# Access Compliance Report

## Public Rights-of-Way

### (Curb Ramps)

Intersection ID: 11685	Main Street: E_19TH_ST	Cross Street: SEIGLE_AV	Location: W
ADA ID: 583800DCE004	Ramp Type: Perp	Initial Pass/Fail: Fail	Overall Compliance: No
Severity Score: 33.75			
Codes/Mitigation Info/Possible Solution		Field Measurements/Component Compliance

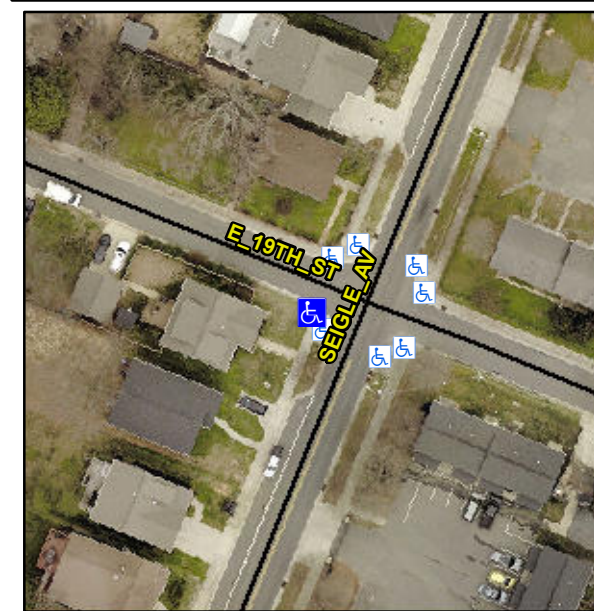
**Not Found, R304.5.1, R304.2.2, R304.5.3**

Compliance	Description	Data	Compliance	Description	Data
N/A	Ramp Length (in)	70.0	No	Ramp Slope (%)	11.5
No	Ramp Width (in)	47.5	No	Ramp XSlope (%)	6.5
N/A	Flare Type LT	N/A	N/A	Flare Type RT	N/A
N/A	Flare Slope LT (%)	N/A	N/A	Flare Slope RT (%)	N/A
N/A	Flare Traversable LT?	N/A	N/A	Flare Traversable RT?	N/A
N/A	Landing Length (in)	N/A	N/A	DWS Provided?	N/A
N/A	Landing Width (in)	N/A	N/A	DWS Contrast?	N/A
N/A	Landing Slope (%)	N/A	N/A	DWS Length (in)	N/A
N/A	Landing X Slope (%)	N/A	N/A	DWS Full Width?	N/A
N/A	Landing Curb? (Y/N)	N/A	N/A	DWS Offset (in)	N/A
N/A	Shared Landing?	N/A			
N/A	Gutter Ponding?	N/A	N/A	Gutter Slope (%)	N/A
N/A	Gutter Lip Ht (in)	N/A	N/A	Gutter X Slope (%)	N/A
N/A	Painted X Walk1?	No	N/A	Painted X Walk2?	N/A
	X Walk 1 Direction	To NE		X Walk 2 Direction	N/A
N/A	X Walk 1 Width (in)	N/A	N/A	X Walk 2 Width (in)	N/A
	X Walk 1 Slope (%)	3.1		X Walk 2 Slope (%)	N/A
	X Walk 1 X Slope (%)	6.6		X Walk 2 X Slope (%)	N/A

**Remove & Replace Entire Ramp.**
